SUBJECT: Preliminary Site Plan Review for 53 First Street, Merino Block Development

PC Case No: 2015-27

RE: PC 2015-27- Preliminary Site Plan review for 53 First Street, Merino Block Development

Date: October 8, 2015
To: Greg Hannan, City Planner
From: Thomas J. Sheridan P.E., P.S.
Re: **53 First Street, Redevelopment of the Merino Block**

PROPOSED SITE PLAN - OPTION 6

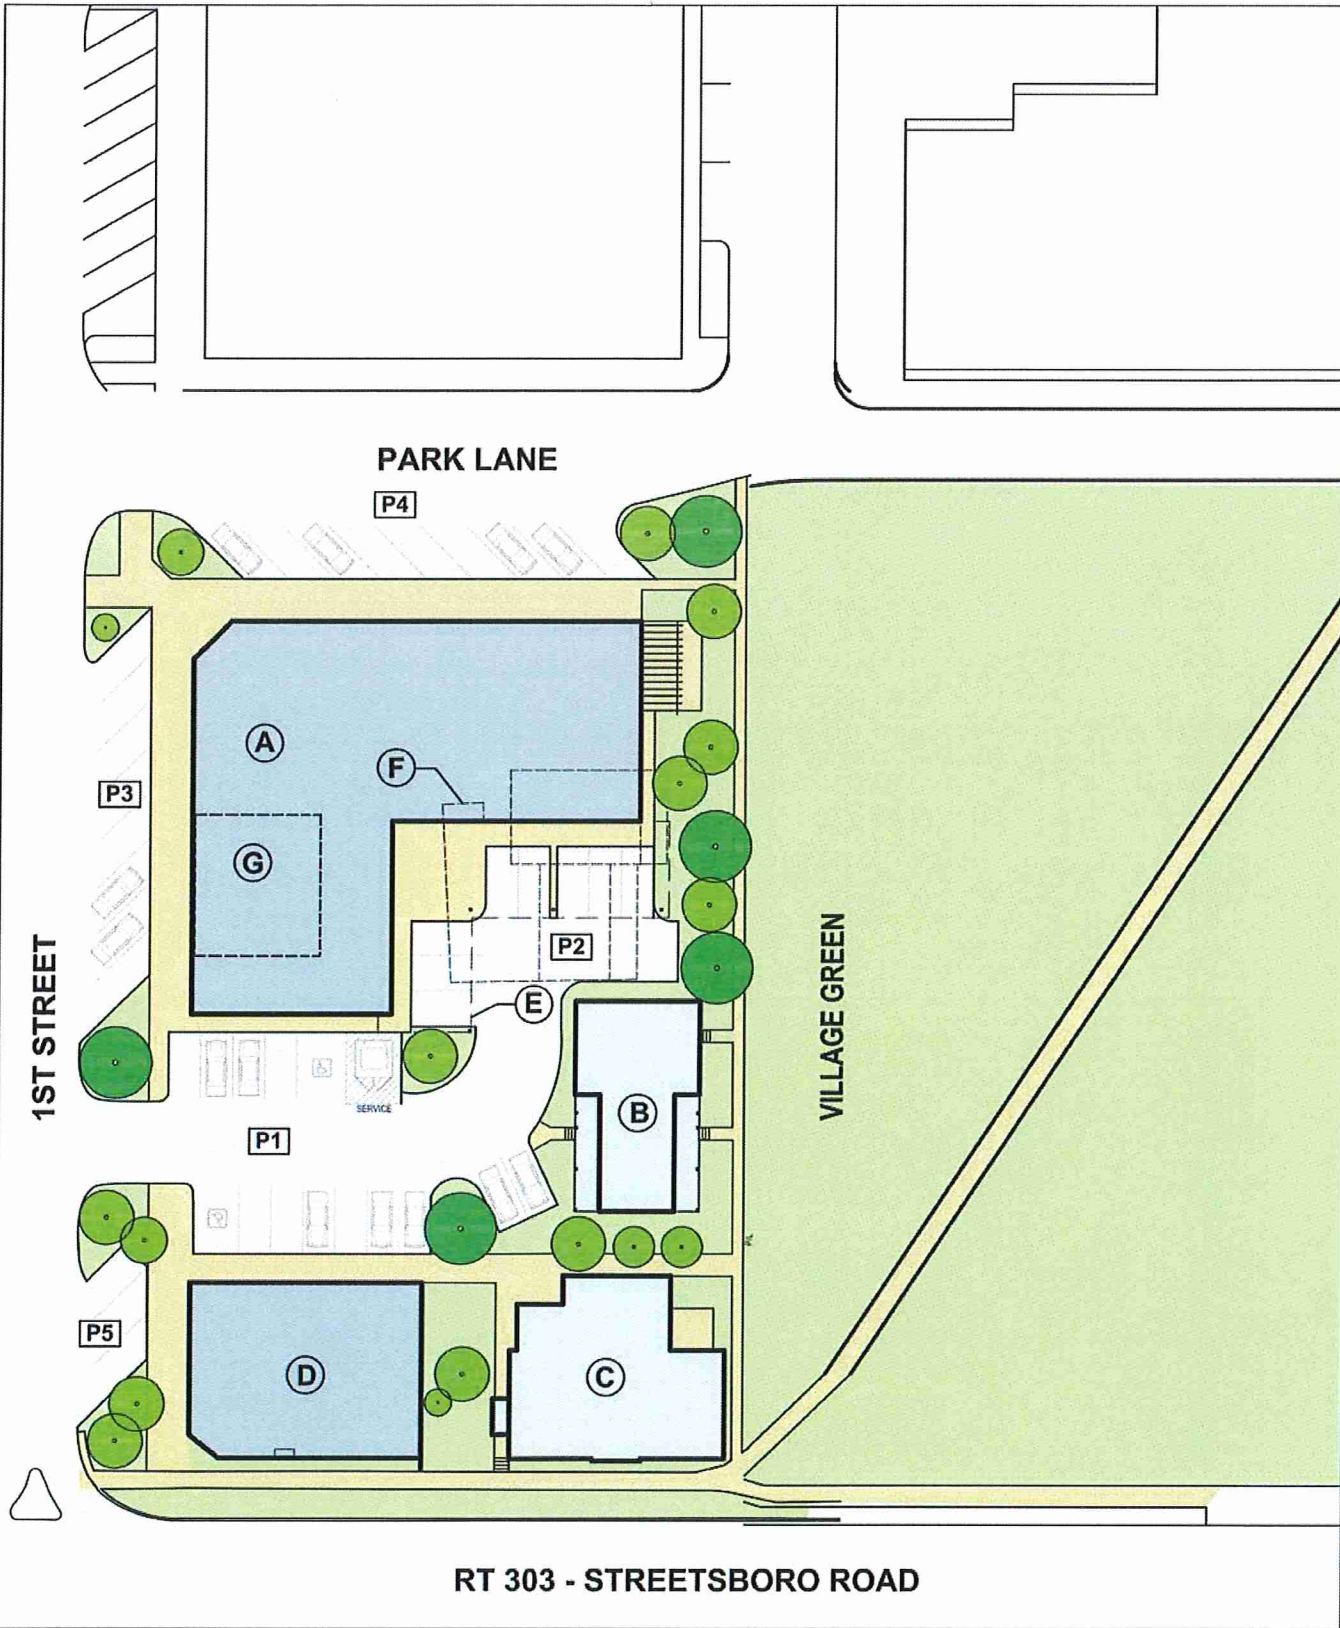
2. Angled parking stalls on First Street: Additional review is needed of the three angled parking stalls proposed south of the access drive. The close proximity of these spaces to vehicles turning onto northbound First Street from West Streetsboro Street may create traffic concerns.

2. The sidewalk at the northeast corner of the site should be revised to provide a larger landing and cross walk to the north. The sidewalk along the eastern property line should maintain a minimum width of five feet.

- a. Indicate the intended use of the first floor commercial spaces for further determination of adequate parking supply.
 - b. Information is needed regarding how resident parking need will be accommodated. Additionally, the city is reviewing downtown parking regulations to determine the ability to accommodate downtown resident parking within on-street and public parking lots.

- c. Additional review is needed of the three angled parking stalls proposed south of the access drive. The close proximity of these spaces to vehicles turning onto northbound First Street from West Streetsboro Street may create traffic concerns.
